# UNITED STATES PATENT AND TRADEMARK OFFICE

10/599,432

<b>Office Action Summary</b>	<b>Application No.</b> 10/599,432	<b>Applicant(s)</b> TOSHIMA ET AL.	
	<b>Examiner</b> THOMAS DIAZ	<b>Art Unit</b> 3656

## **DETAILED ACTION**

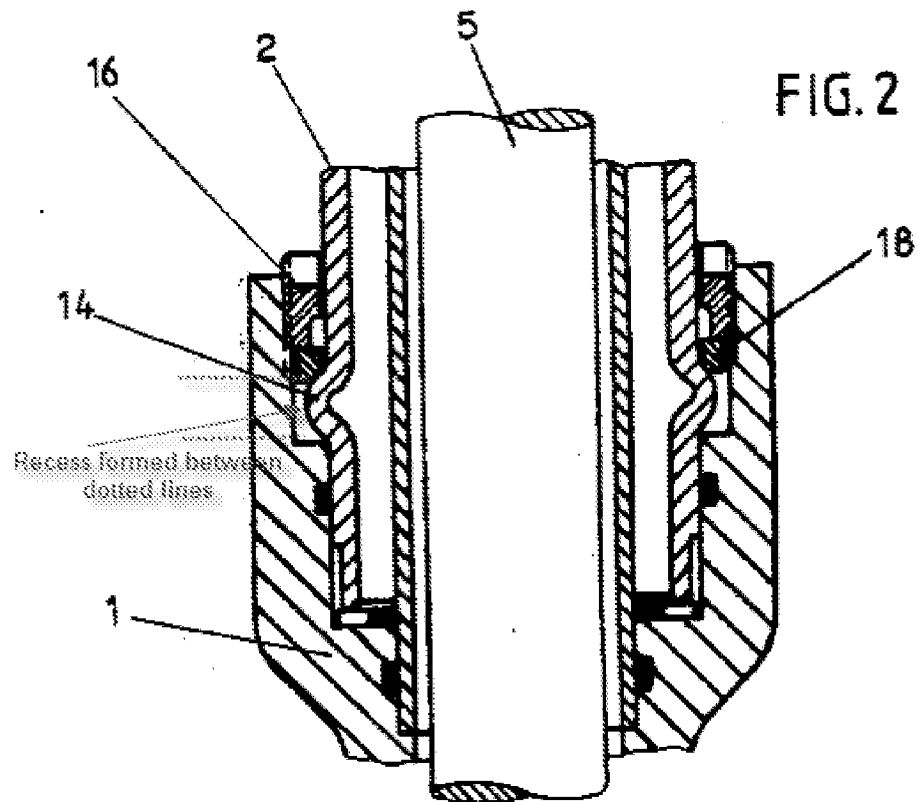
2. Claims 1-3, 5 are rejected under 35 U.S.C. 102(b) as being anticipated by Walter (USP 4307622).

Regarding claims 1-3,5, Walter discloses a similar apparatus comprising:

- a steering drive shaft (fig.2, 5; it is capable of moving in an axial direction) [capable of moving in an axial direction in response to a steering operation];
- a housing (fig.2, 2) accommodating the steering drive shaft and having a tube part (fig.2, 2; is in the form of a tube part) extending in a long axis direction of the steering drive shaft; and

- a bracket (fig.2, combination of 1, 16 and 18; form the bracket) having a fitting hole (fig.2, the hole through which the tube part and steering shaft penetrate axially. The bracket is arranged in a vehicle thus is configured to attach to the vehicle) into which said tube part is fitted in a co-axial direction of the tube part and [configured to attach said housing to a car body], and wherein
- said bracket has a recess (fig.2, see labeled figure below; the recess is the gap between the dotted lines.) in said fitting hole and
- said tube part has at least one escape preventing protrusion (fig.2, 14) bent into said recess and extending in a radial direction of the tube part, for preventing said bracket from escaping.

- said recess is a circular groove (see fig.2, since protrusion 14 is an annular protrusion, the groove is circumferential and thus circular).
- Said tube part is metal (see fig.2, based on the cross-hatching, the tube part is metal).
- Said recess includes a circumferential groove (see fig.2, since protrusion 14 is an annular protrusion, the groove is circumferential and thus circular).
